Development Review Comments

PAM2024-00152

622 Hungerford Drive – Washington Square

WASHINGTON SQUARE
PRE-APPLICATION SITE PLAN
CITY OF ROCKVILLE, MARYLAND

DRAWING NUMBER: PSP-03

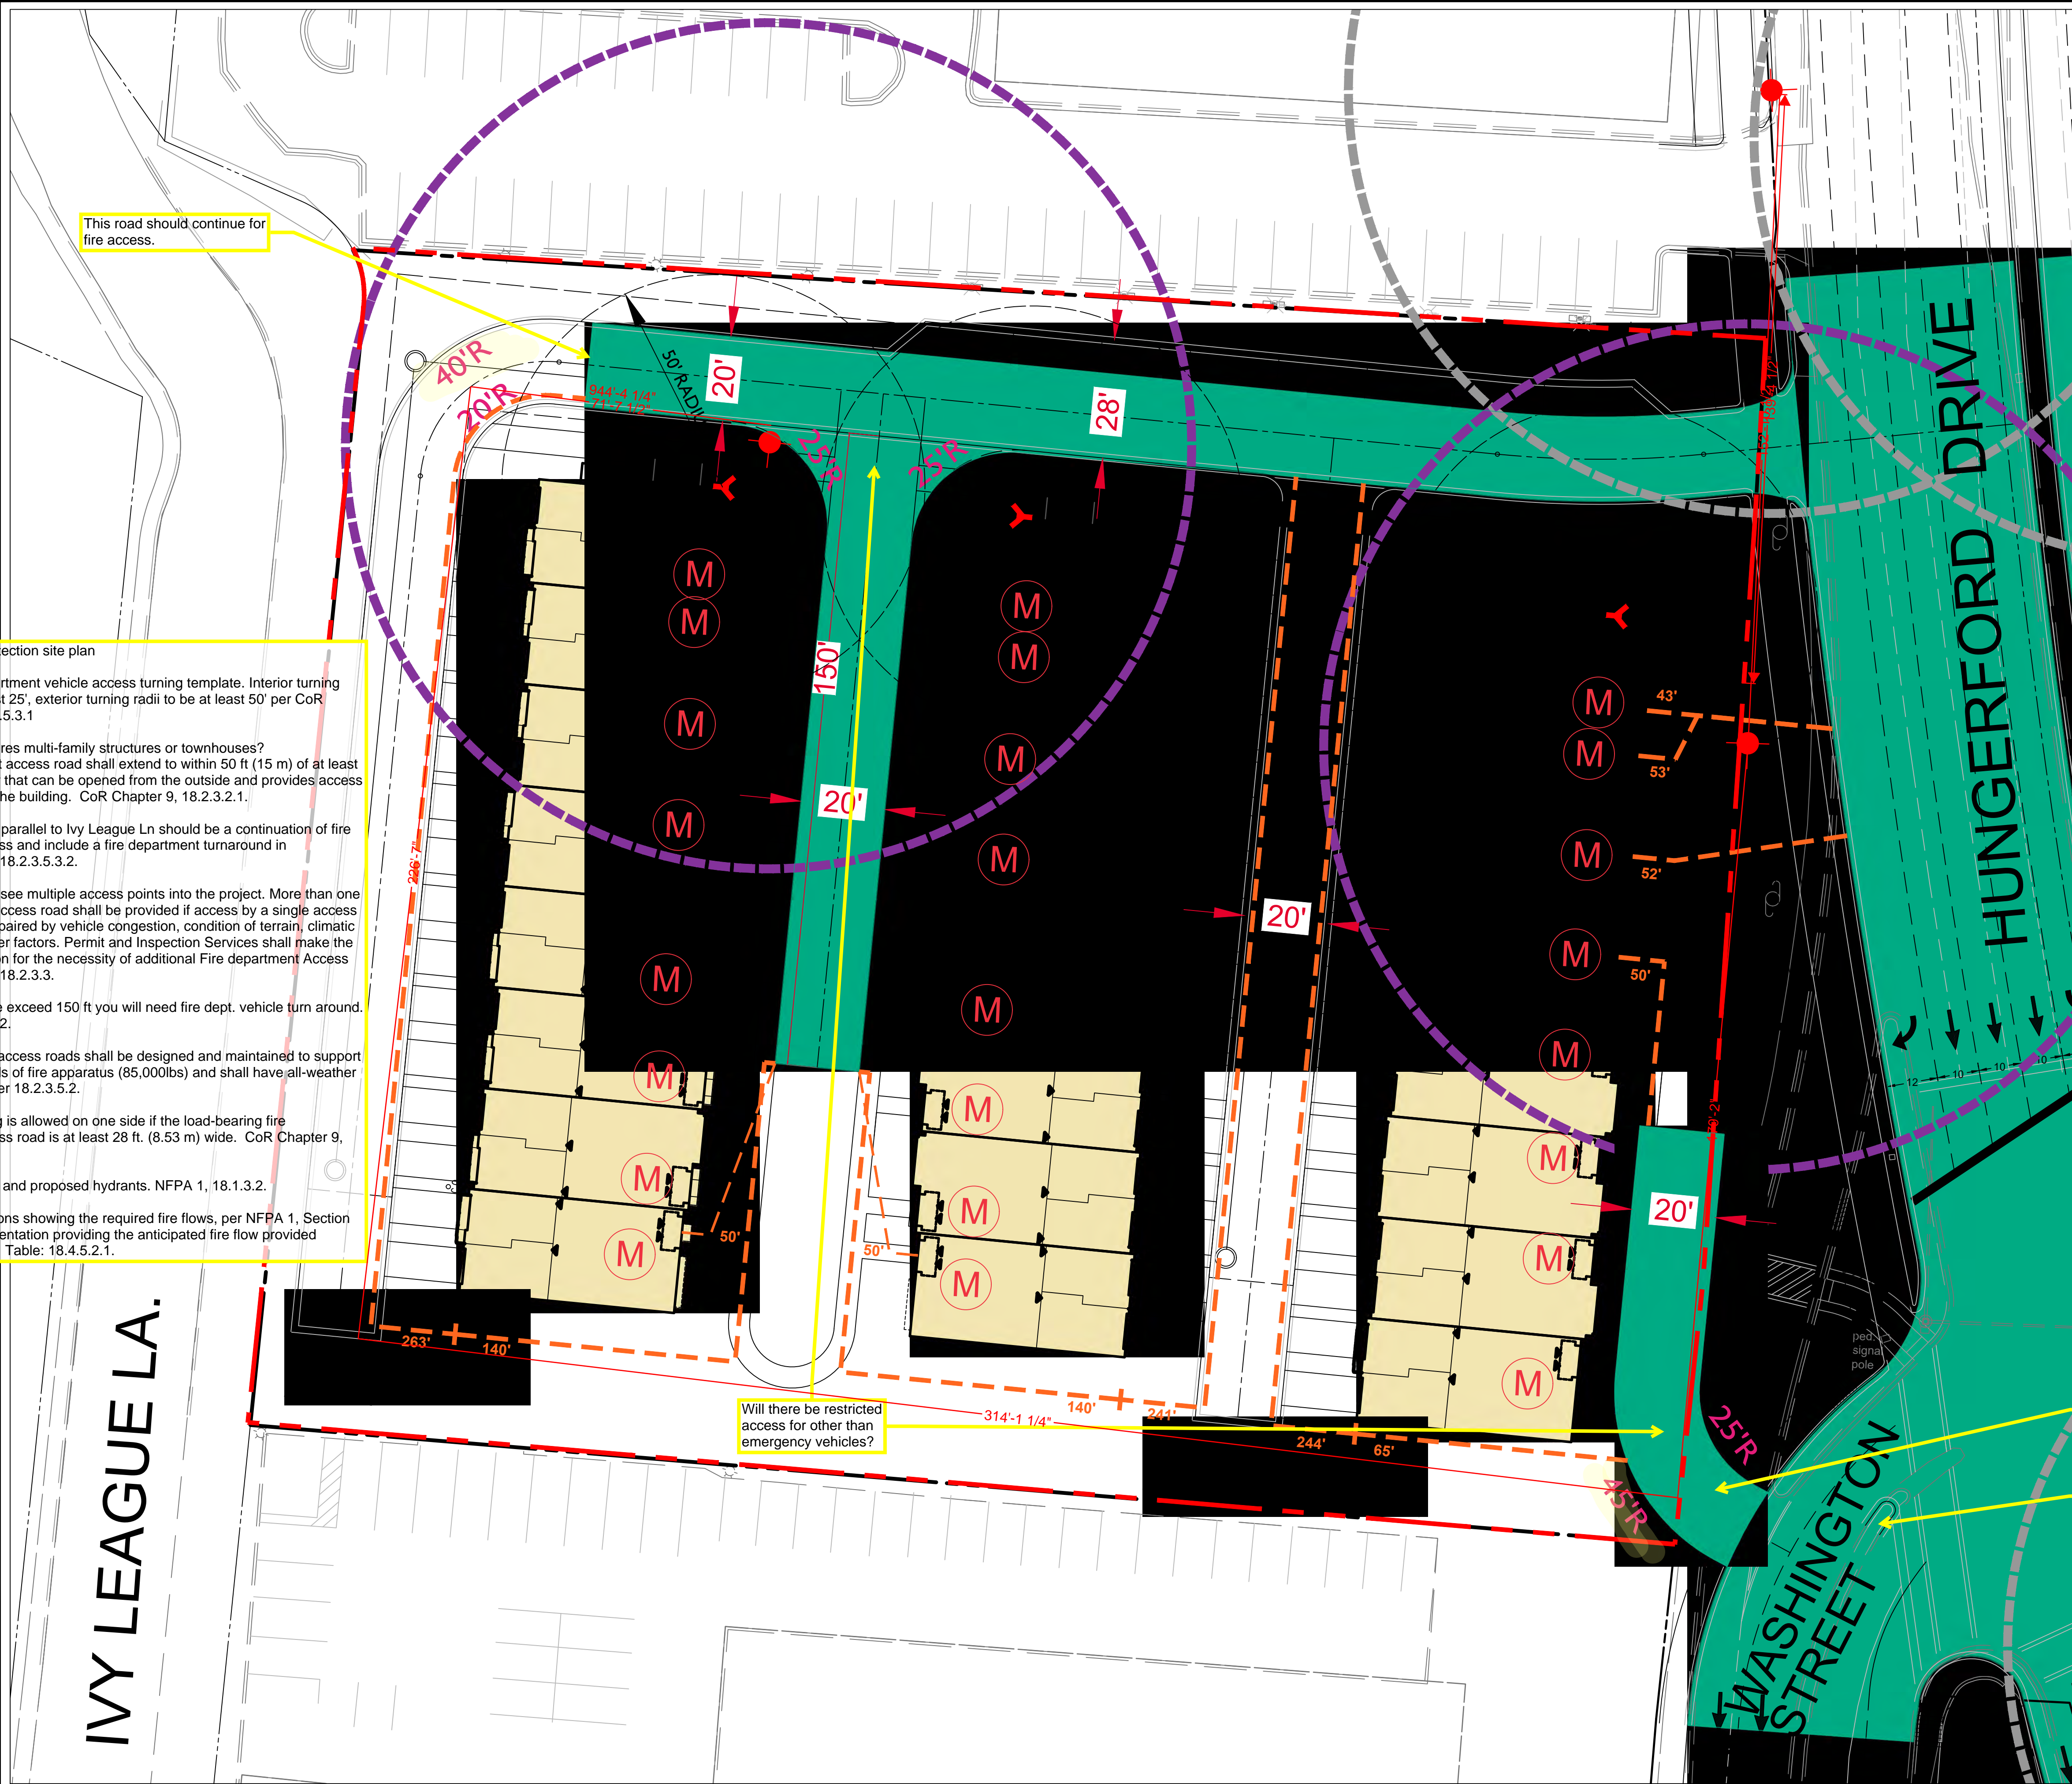
Staff is unclear of how this area will meet the intent of Public Use Space. As defined in the Zoning Ordinance (Sec. 25.03.02), Public Use Space is an open area which, "must be accessible for use and enjoyment by the general public," and provides, "light and air, recreational space, or other similar purpose." Staff is unsure how practically this area would be used by the general public where such areas would seem to function of as the front yards of private homes and include a driveway for fire access. Staff strongly recommends that the design of public use space includes community gathering areas and recreational space that won't be obstructed by vehicle movements, in the spirit and intent of Public Use space as defined in the Ordinance.

How will the development address the design guidelines for central features and community spaces outlined in Sec. 25.13.06.c.6?

Submit a fire protection site plan

Where drive aisle exceed 150 ft you will need fire dept. vehicle turn around. COR, 18.2.3.5.3.2.

If you plan to have parking on one side drive aisles need to be 28ft.

We would like to see multiple access points into the project. More than one fire department access road shall be provided if access by a single access road could be impaired by vehicle congestion, condition of terrain, climatic conditions or other factors. Permit and Inspection Services shall make the final determination for the necessity of additional Fire department Access Roads. NFPA 1, 18.2.3.3.

Show all existing and proposed hydrants. NFPA 1, 18.1.3.2.

Provide calculations showing the required fire flows, per NFPA 1, Section 18.4. and documentation providing the anticipated fire flow provided on-site. NFPA 1, Table: 18.4.5.2.1.

DRAWING NUMBER **EXB-02**
2023.09.29 - 05:17 PM

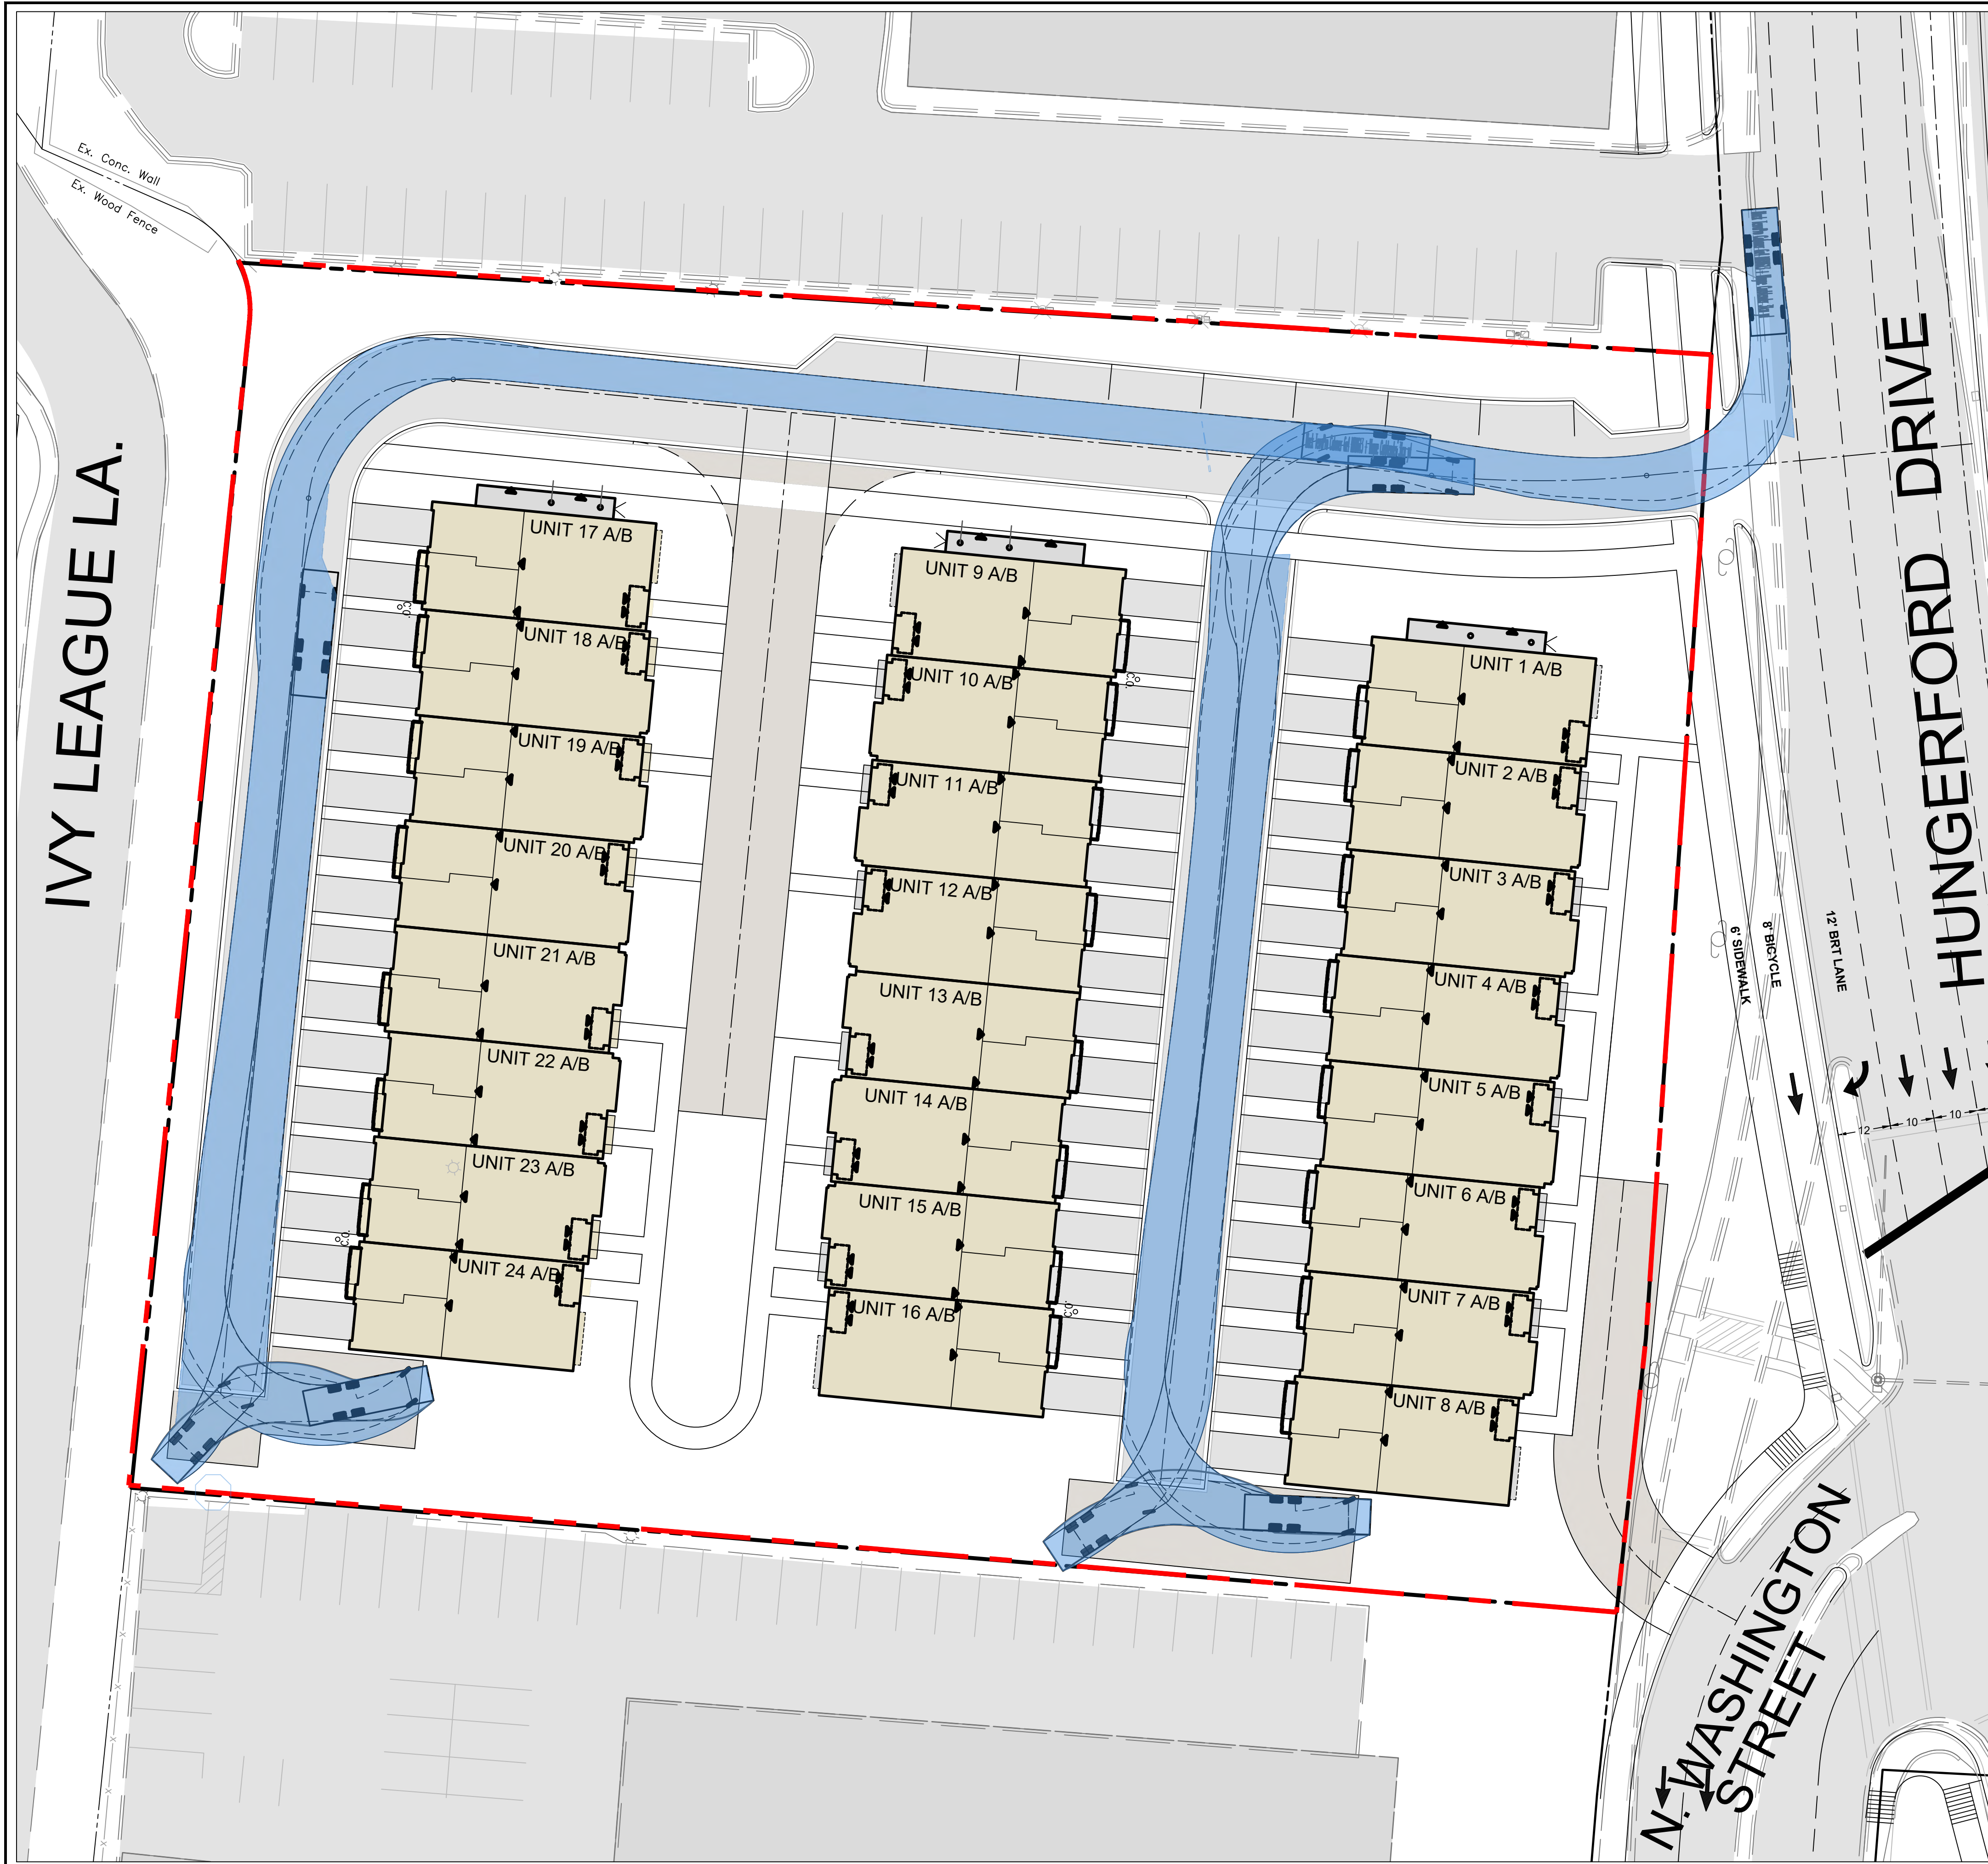
This road should continue for fire access.

Submit a fire protection site plan

Provide fire department vehicle access turning template. Interior turning radii to be at least 25', exterior turning radii to be at least 50' per CoR Chapter 9 18.2.3.5.3.1

Are these structures multi-family structures or townhouses?
A fire department access road shall extend to within 50 ft (15 m) of at least one exterior door that can be opened from the outside and provides access to the interior of the building. CoR Chapter 9, 18.2.3.2.1.

Roadway shown parallel to Ivy League Ln should be a continuation of fire department access and include a fire department turnaround in accordance with 18.2.3.5.3.2.

We would like to see multiple access points into the project. More than one fire department access road shall be provided if access by a single access road could be impaired by vehicle congestion, condition of terrain, climatic conditions or other factors. Permit and Inspection Services shall make the final determination for the necessity of additional Fire department Access Roads. NFPA 1, 18.2.3.3.

Where drive aisle exceed 150 ft you will need fire dept. vehicle turn around. COR, 18.2.3.5.3.2.

Fire department access roads shall be designed and maintained to support the imposed loads of fire apparatus (85,000lbs) and shall have all-weather driving surface per 18.2.3.5.2.

On-street parking is allowed on one side if the load-bearing fire department access road is at least 28 ft. (8.53 m) wide. CoR Chapter 9, 18.2.3.5.1.1.1

Show all existing and proposed hydrants. NFPA 1, 18.1.3.2.

Provide calculations showing the required fire flows, per NFPA 1, Section 18.4. and documentation providing the anticipated fire flow provided on-site. NFPA 1, Table: 18.4.5.2.1.
